**Government of Pakistan  
Revenue Division  
Federal Board of Revenue  
(Pakistan Raises Revenue Program Office)**

Re. No. 3(7)/2026-Addl-Dir(P&F) / 565389

**Subject: MINUTES OF PRE-BID MEETING AND RESPONSES TO THE CLARIFICATION - FRAMEWORK AGREEMENT FOR THE PROCUREMENT AND INSTALLATION OF EXTERNAL ELECTRIFICATION SYSTEMS FOR DIGITAL ENFORCEMENT STATIONS (DES) AT INDUS SITES, PHASE-I (10 SITES).**

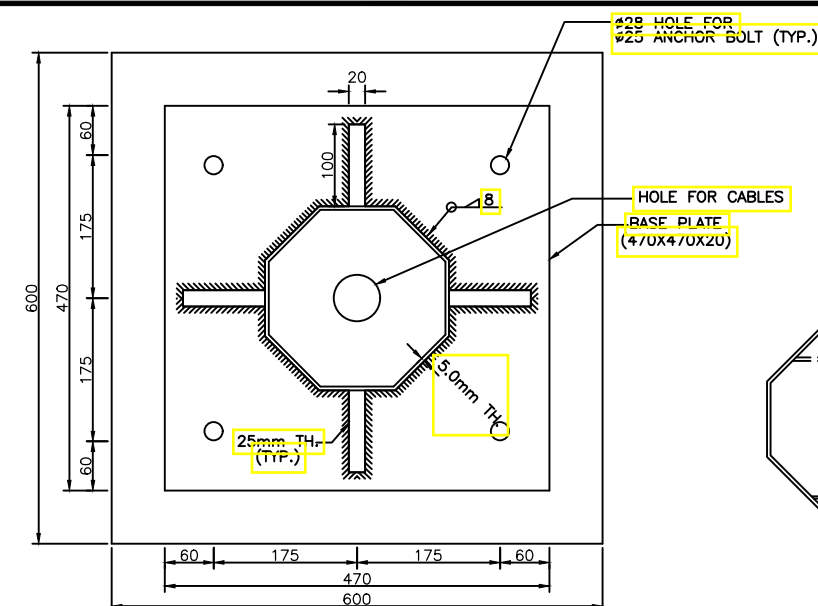
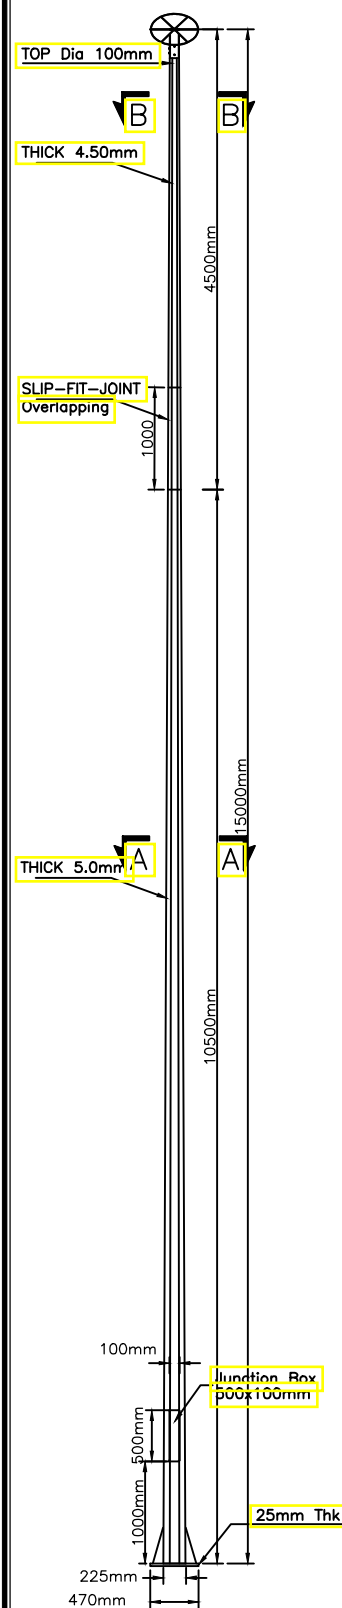
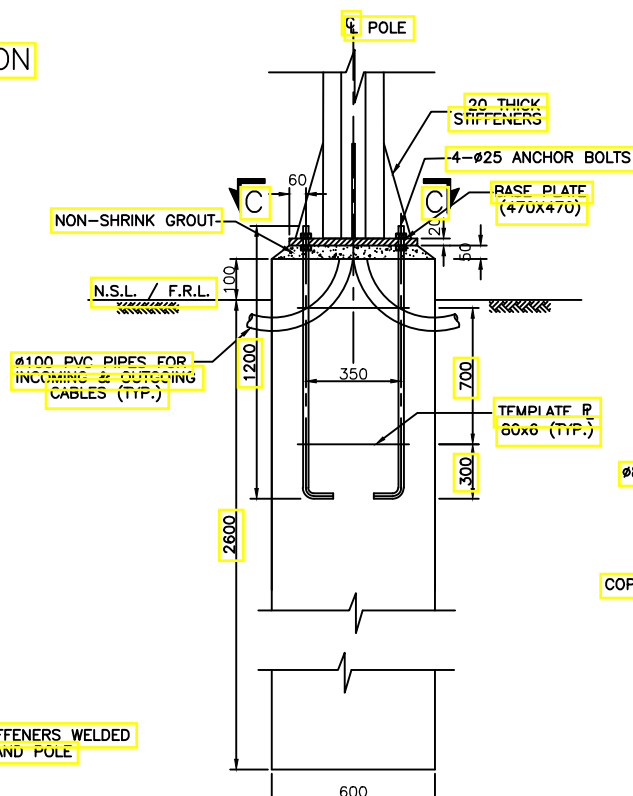
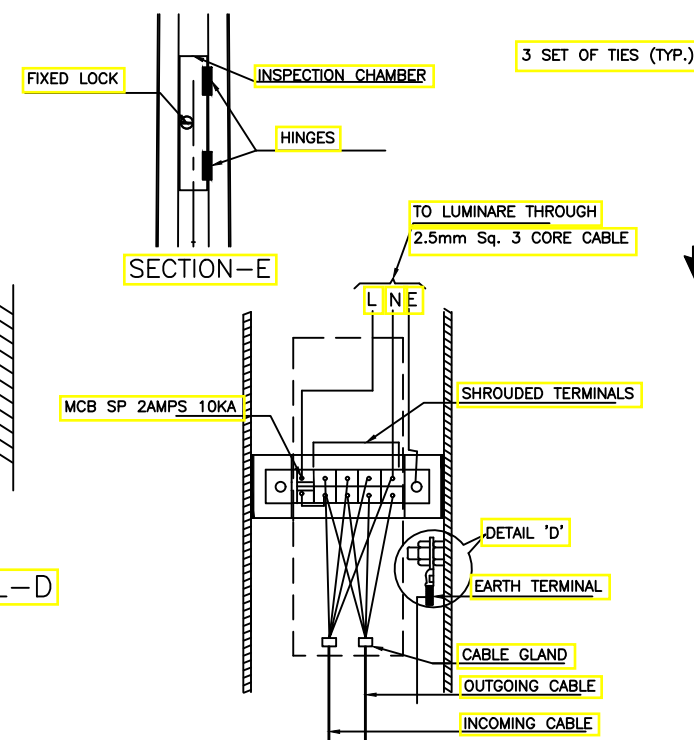
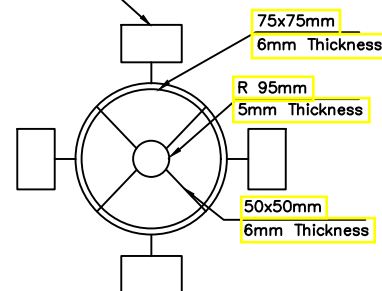
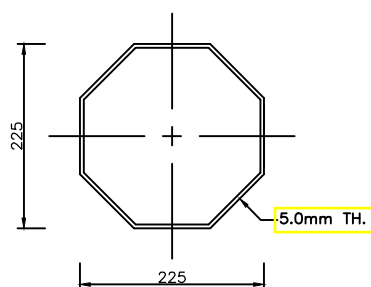
| <b>LOT # 01 - Site 01: DI KHAN HAKLA MOTORWAY M-14(CPEC) (BOQ-01)</b> |                                                                                                                                             |                                                                                                                                                                                                                                                                                                                                                              |
|-----------------------------------------------------------------------|---------------------------------------------------------------------------------------------------------------------------------------------|--------------------------------------------------------------------------------------------------------------------------------------------------------------------------------------------------------------------------------------------------------------------------------------------------------------------------------------------------------------|
| <b>Poles<br/>1(a) to 1(d)</b>                                         | <b>1.</b> Please share Drawing (12m Single bent)                                                                                            | <b>1.</b> Attached at <b>Annex-1</b>                                                                                                                                                                                                                                                                                                                         |
|                                                                       | <b>2.</b> Please share Drawing (12m Double bent)                                                                                            | <b>2.</b> Attached at <b>Annex-1</b> (Included)                                                                                                                                                                                                                                                                                                              |
|                                                                       | <b>4.</b> Road Lighting Pole Foundation                                                                                                     | <b>4.</b> Foundation details for the applicable road-lighting poles are included in the respective pole drawings provided at Annexes 1 and 2. The Bidder shall follow the applicable drawing together with the BOQ and Technical Specifications.                                                                                                             |

| <b>LOT # 01 - Site 01: DI KHAN HAKLA MOTORWAY M-14(CPEC) (BOQ-01)</b> |                                                                                                                                             |                                                                                                                                                                                                                                                                                                                                                              |
|-----------------------------------------------------------------------|---------------------------------------------------------------------------------------------------------------------------------------------|--------------------------------------------------------------------------------------------------------------------------------------------------------------------------------------------------------------------------------------------------------------------------------------------------------------------------------------------------------------|
|                                                                       | <b>3.</b> Please share Drawing (15 m high conical octagonal)                                                                                | <b>3.</b> Attached at <b>Annex-2</b><br><br>All the drawings shall be read together with the relevant BOQ and Technical Specifications.                                                                                                                                                                                                                      |

**MAIN SINGLE LINE DIAGRAM**

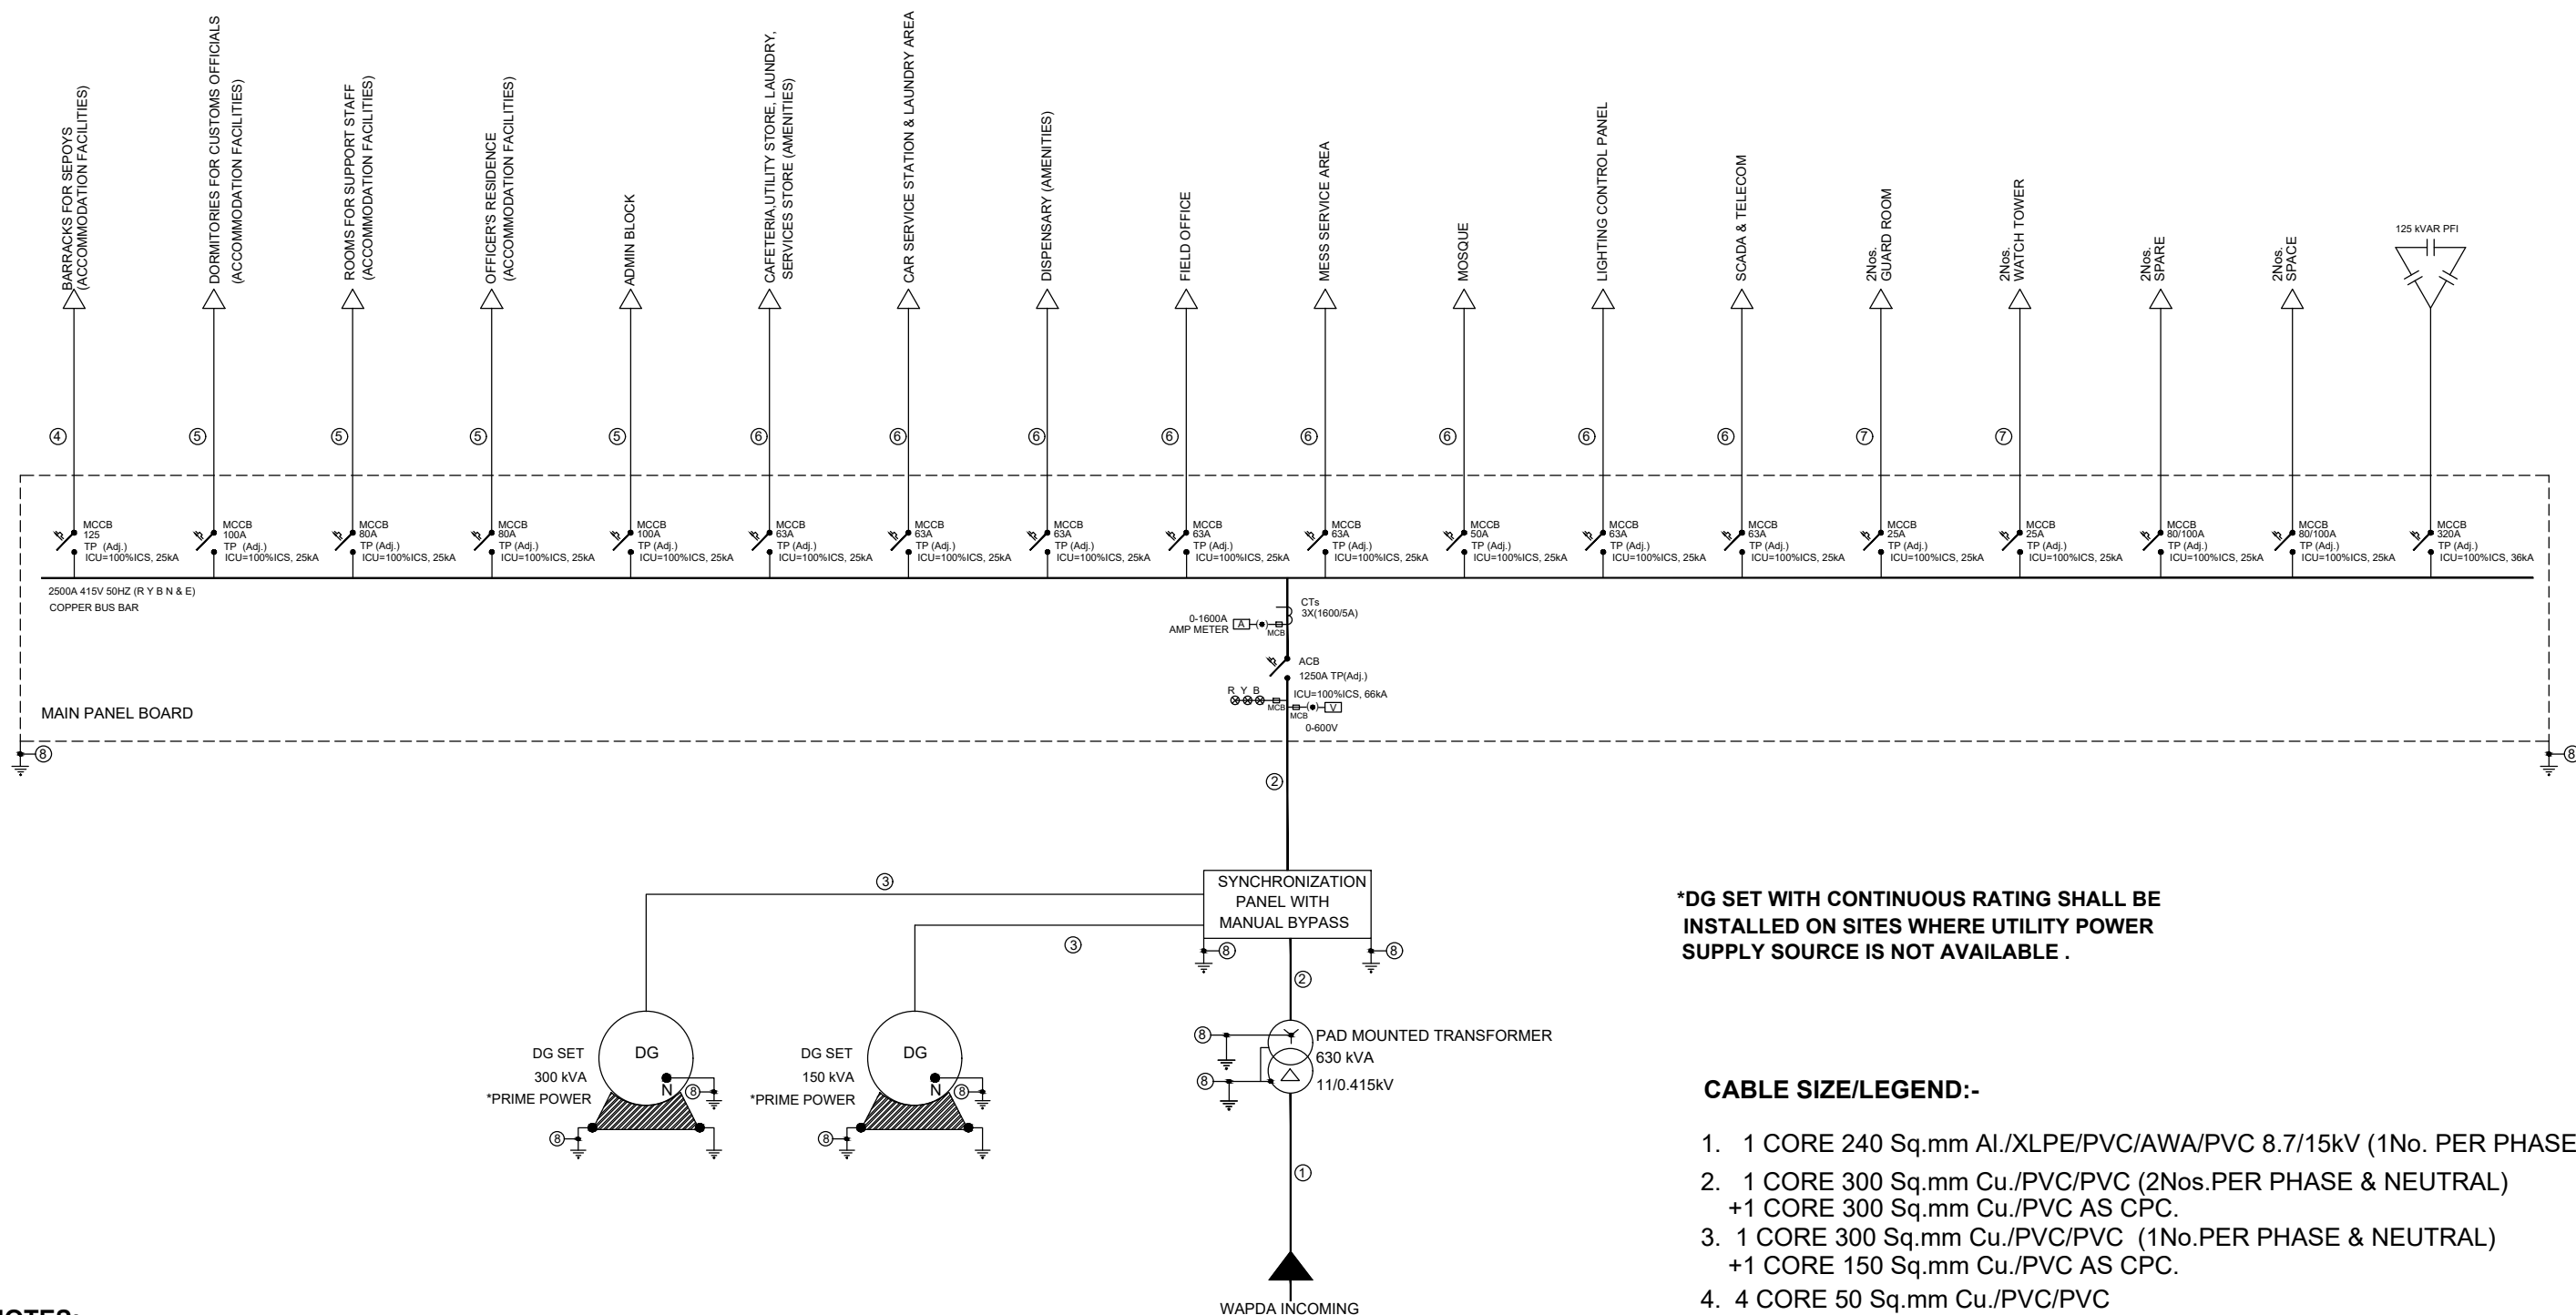
| <b>Low Voltage Power Cables 5(a) &amp; 5(b)</b>                        | <b>10.</b> Please clarify as Transformer rating is 630KVA and 400KVA on this site and if we assume this cable 50mm 4 core for Transformer output then its size is not correct. Please clarify for which purpose this Cable will be used. SLD + Drawing required. | <b>10. Every size is correct</b> , SLD is attached <b>Annex-3</b> .                                                                                                                                                                                                        |
|                                                                        | <b>11.</b> Pls share SLD + Drawing for all types of cables                                                                                                                                                                                                       | <b>11. SLD Attached at Annex-3</b><br><br>Cable applications/connections shall be in accordance with the SLD, BOQ and Technical Specifications. Detailed routing/shop drawings shall be prepared by the Supplier and submitted for approval as required under Section VII. |
| <b>Main Panel Board</b>                                                | <b>12.</b> As here is Two Panels one is 800 Amp and Second 1250Amp SLD + Drawing required cum O/G Supply with the following specs:<br>Will One panel install with 400KVA and Second Panel with 630KVA Transformer                                                | <b>12.</b> Yes,<br>SLD Attached at <b>Annex-3</b> ,<br>Placement Layout (substation room is already shared in RFP)                                                                                                                                                         |

|                                                      | <b>20.</b> Drawing + SLD required                                                                                                                                                                                                   | <b>20.</b> Attached at Annex-3, shall be read together with the BOQ and Technical Specifications.                                                                                                                                                                                                                                                                                                                                                                                                                                                                                                                          |
